PROJECT: John W. Bonner E.S. Addition

SUBMITTAL: 1st

CITY OF LAS VEGAS		DATE:
INTER-OFFICE MEMORANDUM		August 28, 2018
TO: Land Development Services Department of Building & Safety		FROM: Albert Sung, P.E. Flood Control Project Engineer Department of Public Works
SUBJECT:	Drainage Study for:	
	John W. Bonner E.S. Addition	
Cross Streets:	NWC Oxford Cross Drive & Crestdale Lane	
File Number:	F:\Depot\DSMemos\DS5025A.doc	
Parcel Number:	137-25-310-002	
Zoning Action:	CRG-73778	
FEMA Flood Zone	YES	NO X
Proposed Storm Drain	YES X	NO
COPIES TO:		
		Lochsa Engineering
		Clark County School District
		Bart Anderson, P.E., DevCo

15 SECTION THROUGH SOUTHSIDE OF BUILDING NOT TO SCALE

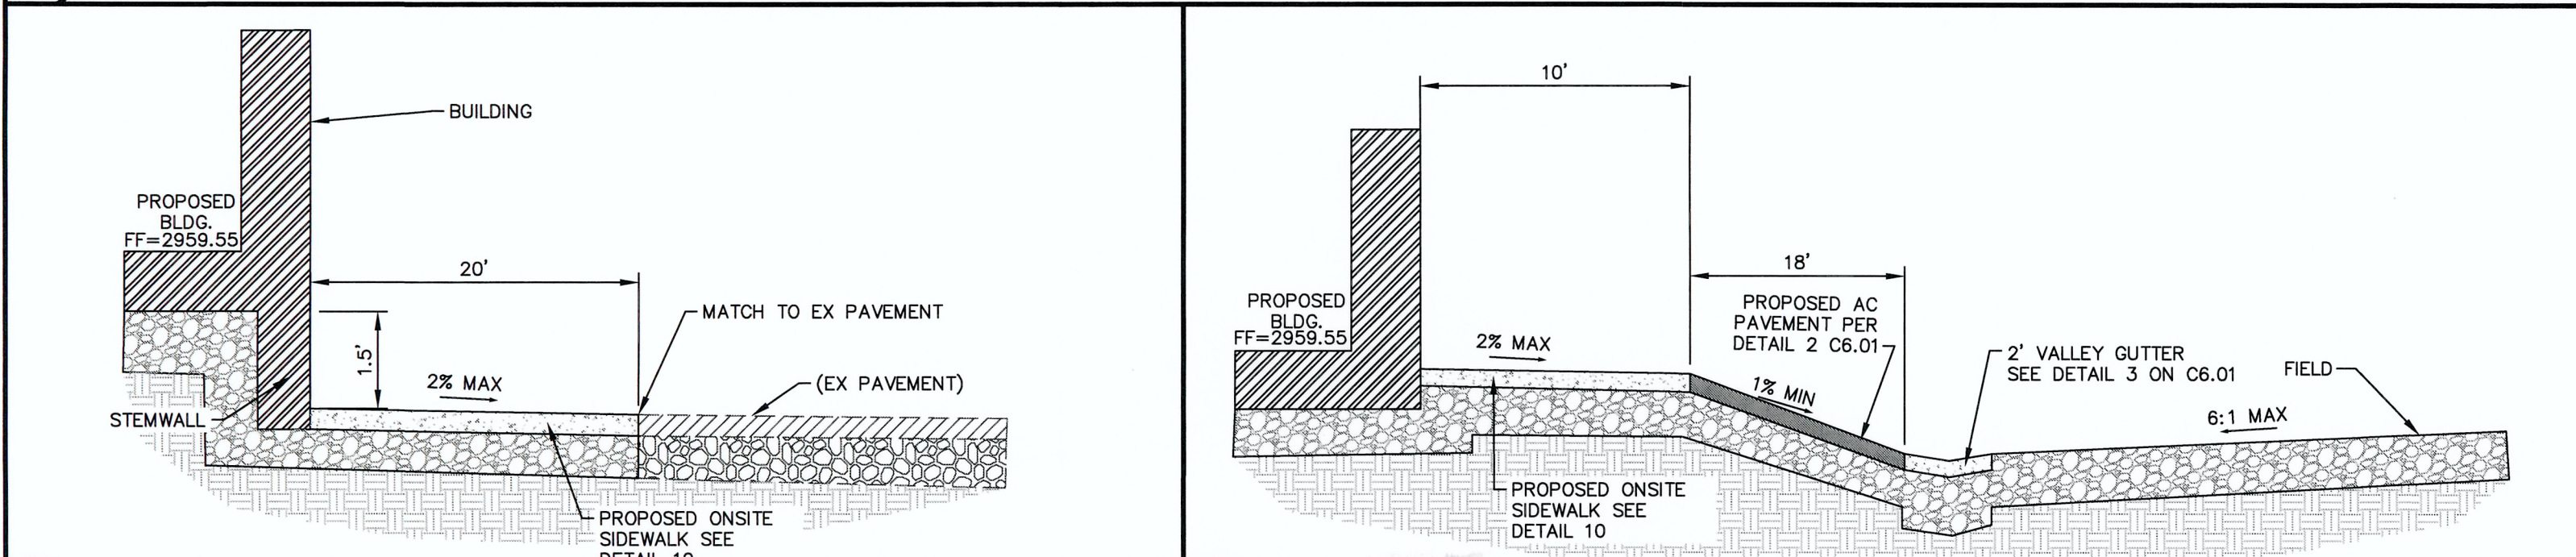
- The proposed onsite sidewalk on the south side of the proposed building has a slope of 4.7%, however, as shown in *Detail Section 15/C6.01*, the sidewalk has a maximum slope of 2%, review and revise accordingly.
